ADDENDUM NO. 19

**CITY OF HIALEAH
9 UNITS ELDERLY HOUSING
45 W 6TH ST
HIALEAH, FLORIDA**

The original Contract Documents, for the Project entitled **CITY OF HIALEAH – 9 Units Elderly Housing, ELECTRICAL BID NO. 2010/11-3230-00-030** is hereby amended as noted in this **Addendum No. 19**.

SITE PLAN
ENTRANCE CABLE
 45 W 6TH ST
 N.T.S.

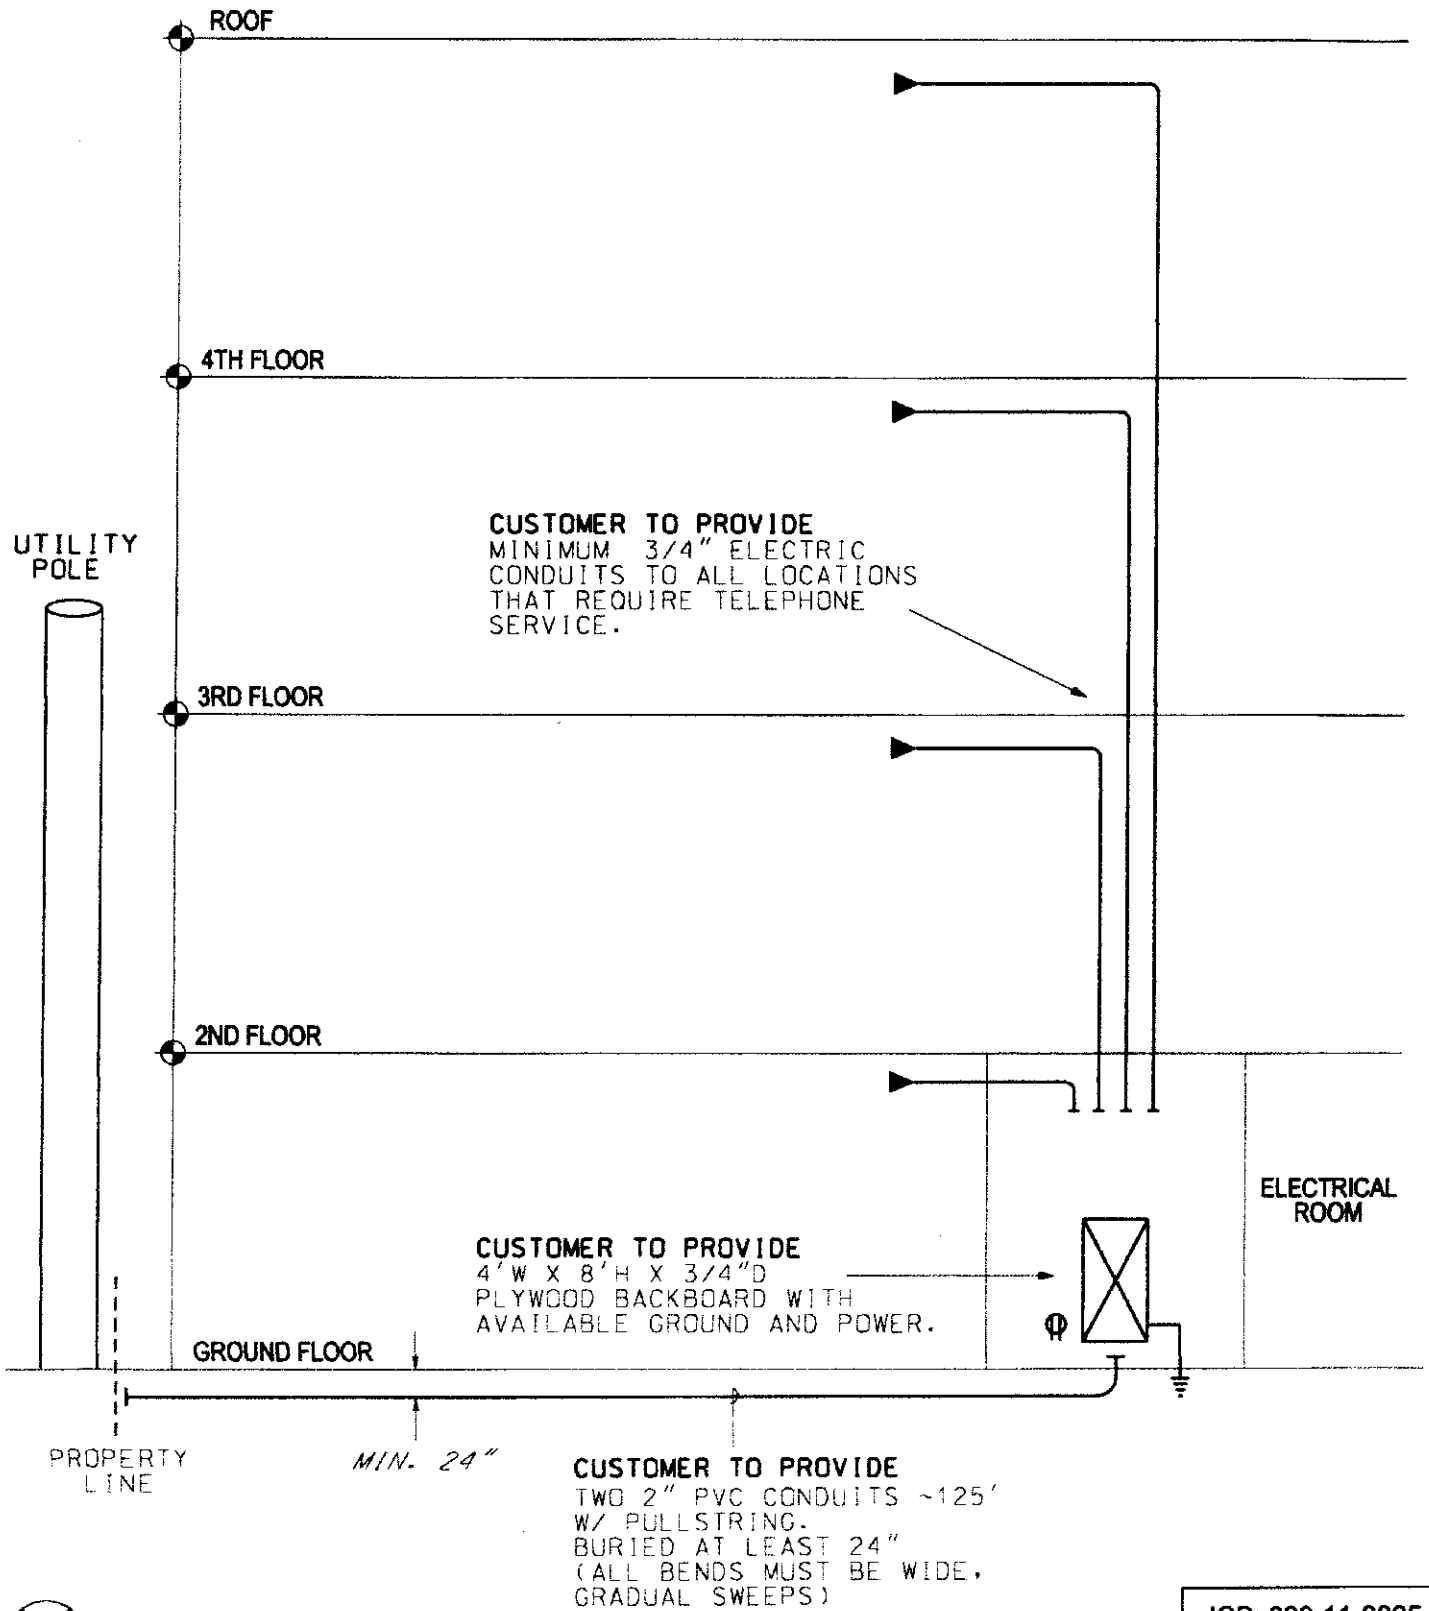
10. There will be no light fixture on top of each apartment main entrance door.
11. Electrical contractor must comply with all AT&T requirements:
 - a) Installation of 2 – 2” PVC conduits, with pull string, from electrical room to utility pole. See note 1 on DWG 1 of 6.

- ① CUSTOMER TO PROVIDE TWO 2" PVC CONDUITS ~125' W/ PULLSTRING. BURIED AT LEAST 24" (ALL BENDS MUST BE WIDE, GRADUAL SWEEPS) FROM THE UTILITY POLE INTO THE ELECTRICAL ROOM ON THE GROUND FLOOR.
